## STARKER AVENUE RESURFACING ASSESSMENT DISTRICT - 2024

CITY PROJECT NO. 14780  
CONTRACT NO. 8759

**Addendum 1 - RJN - 11/8/24**  
 - Changed "install temp hydrant to "install temp flushing device"

**STARKER AVE - WATER MAIN PLAN & PROFILE**

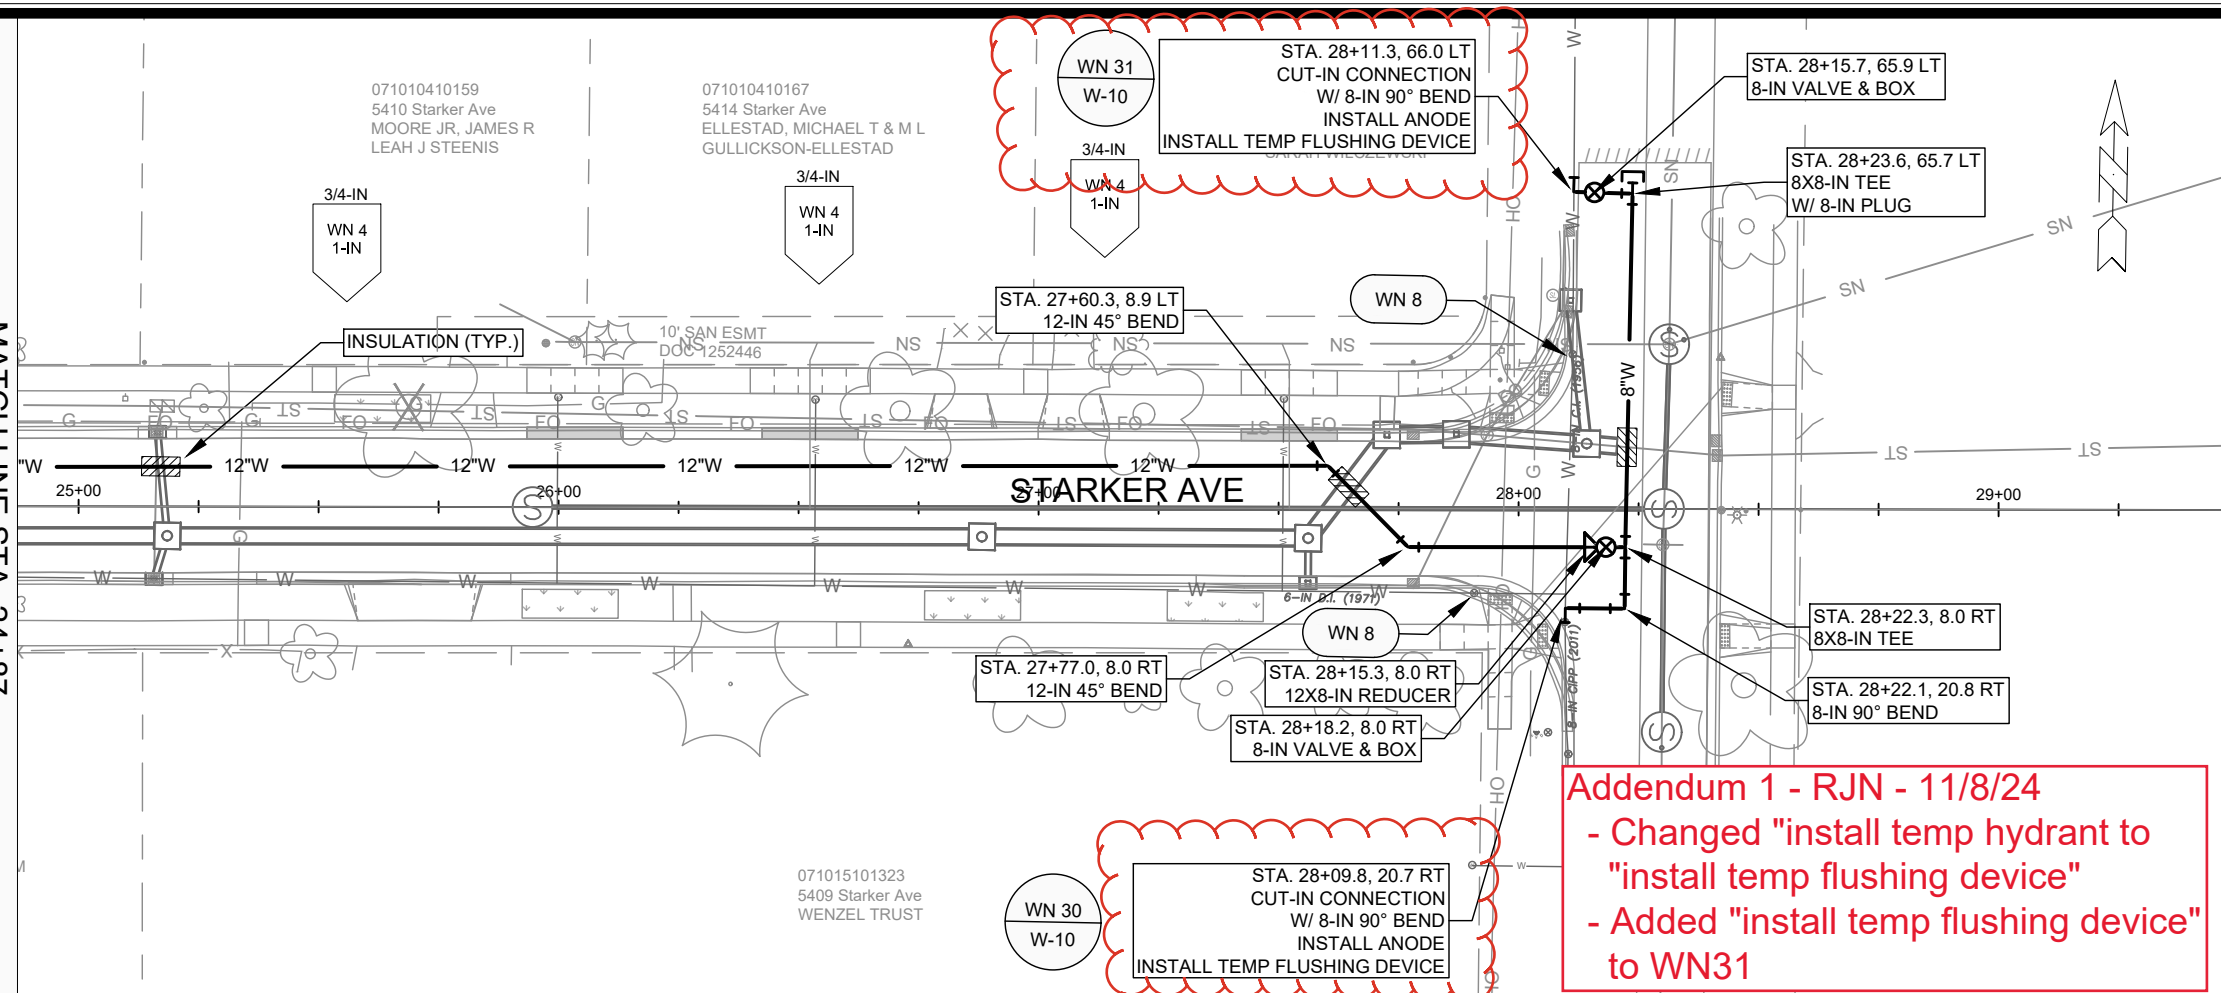
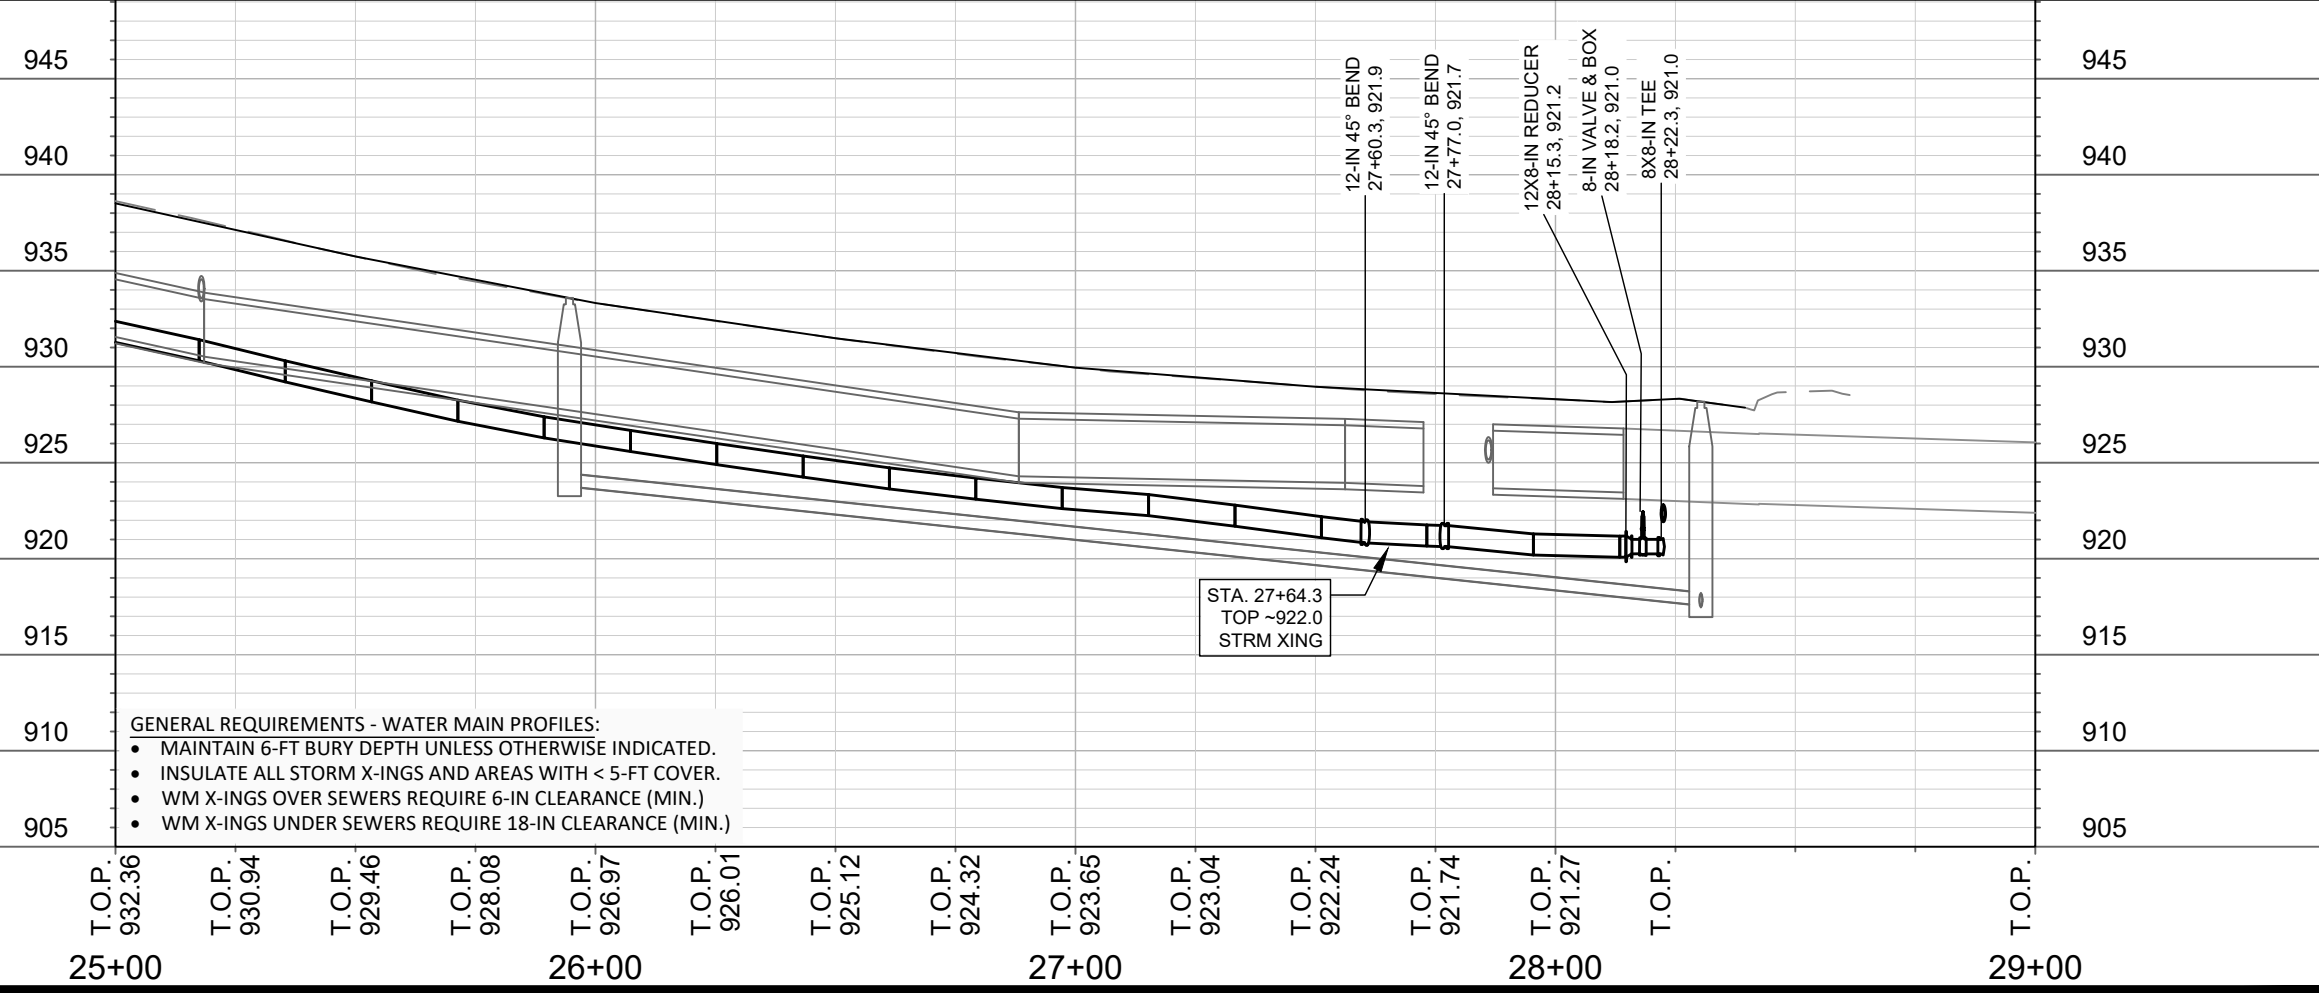
**Addendum 1 - RJN - 11/8/24**  
 - Changed "install temp hydrant to  
 "install temp flushing device"  
 - Added "install temp flushing device"  
 to WN31
